<b>TO:</b>	City of Lee's Summit Attn: Gene Williams, PE 220 SE Green Street Lee's Summit, MO 64063
<b>FROM:</b>	Brock Worthley, PE
<b>RE:</b>	Osage Development Design and Construction Manual Design Modification Request
<b>DATE:</b>	March 17, 2020
<b>PROJECT #:</b>	A19-2339
<b>PHASE:</b>	300
<b>TASK:</b>	300008

## DESIGN AND CONSTRUCTION MANUAL DESIGN MODIFICATION REQUEST

PROJECT NAME: Osage

# OSAGE WAIVER REQUEST C1 DRAINAGE MAP EXHIBIT 1

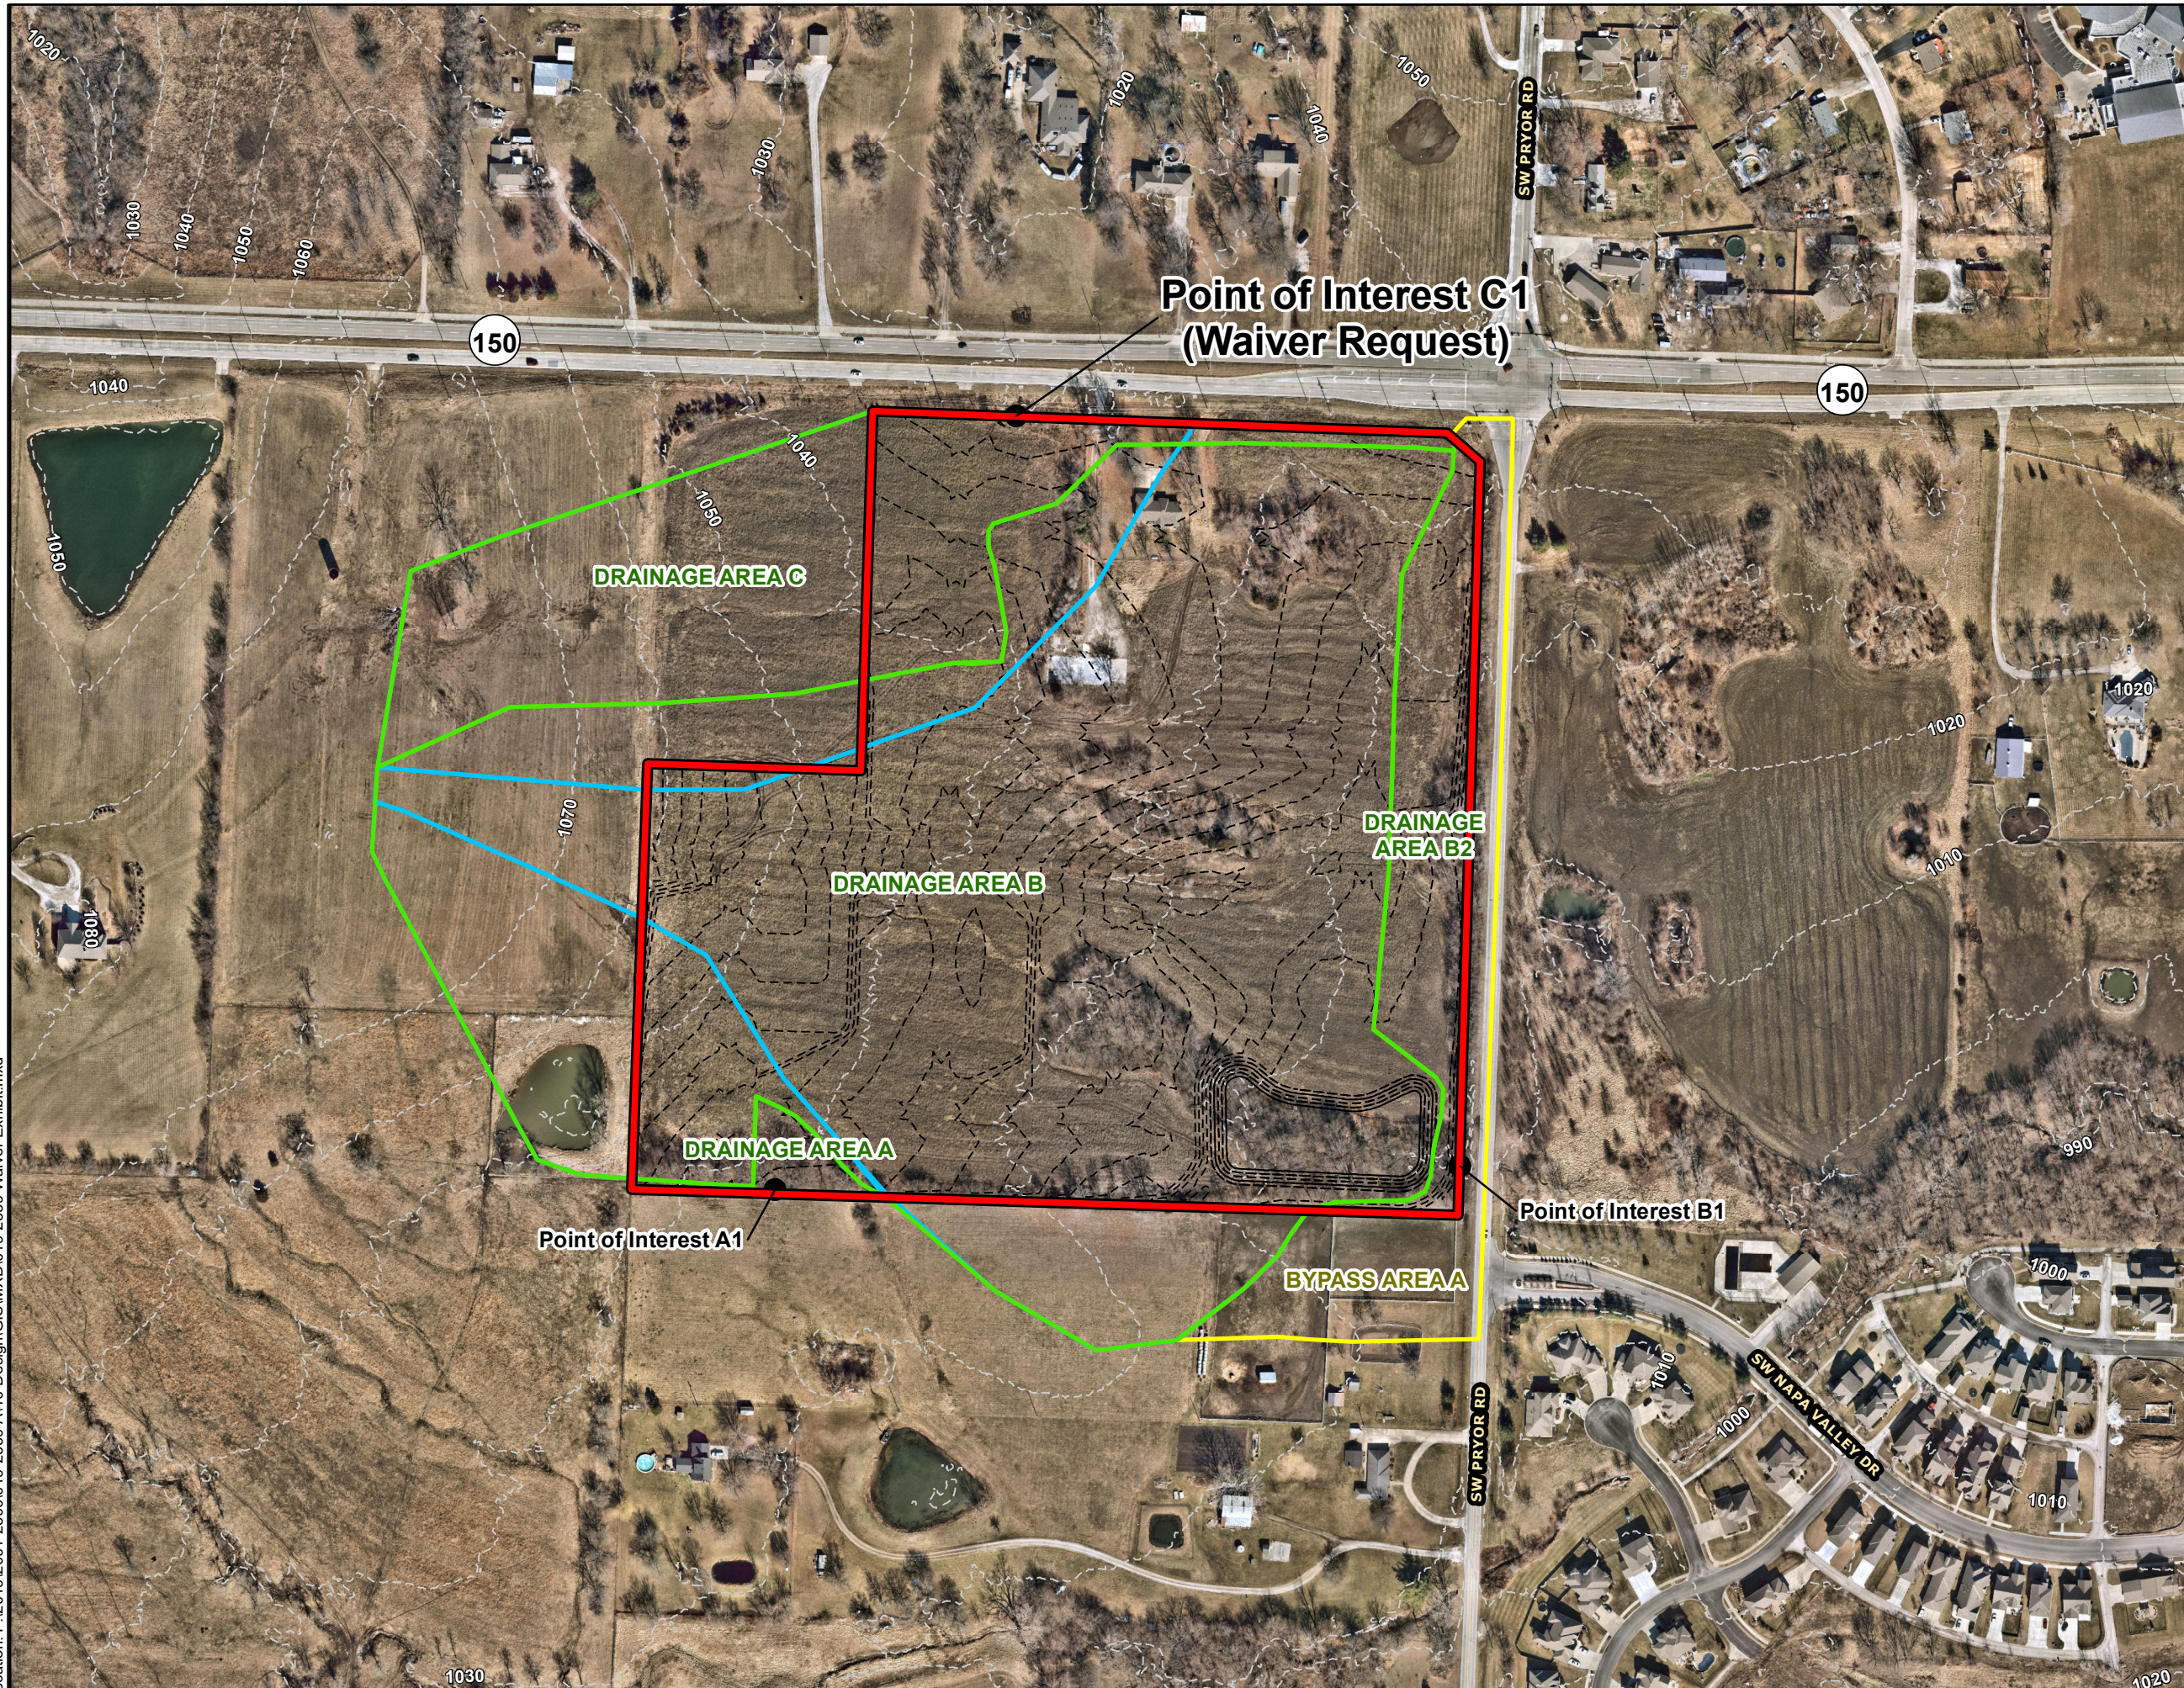
The release rate for the 2-year storm event at Point C1 per the drainage study will be exceeded, but the peak flow rate will be less than existing.

See the attached Exhibit 1. While the detention facility was strategically placed to capture the majority of the developed, on-site area, drainage area C will bypass the facility. However, changes in ridgeline resulting from proposed grading will decrease the area draining to this discharge point from 11.27 acres in existing conditions to 8.25 acres in proposed conditions, of which only 2.6 acres is developed with Osage. The 2-year existing storm event for this discharge point was analyzed and compared to the proposed conditions. The proposed conditions peak flow rate at this point is 17.8% lower than existing conditions, resulting from the previously mentioned decrease in drainage area. The modeled 2-year peak discharge rate at this point for proposed conditions is 20.9 cfs. The modeled 2-year peak discharge rate in existing conditions is 25.4 cfs and the allowable release rate is 18.3 cfs. This means that the proposed release rate is 2.6 cfs higher than the prescribed allowable release rate, but 4.8 cfs lower than the existing peak flow rate. The 10-year and 100-year storm events meet Section 5608.4.C.1.a requirements for allowable discharge, so this waiver is only for the 2-year event for Point C1.
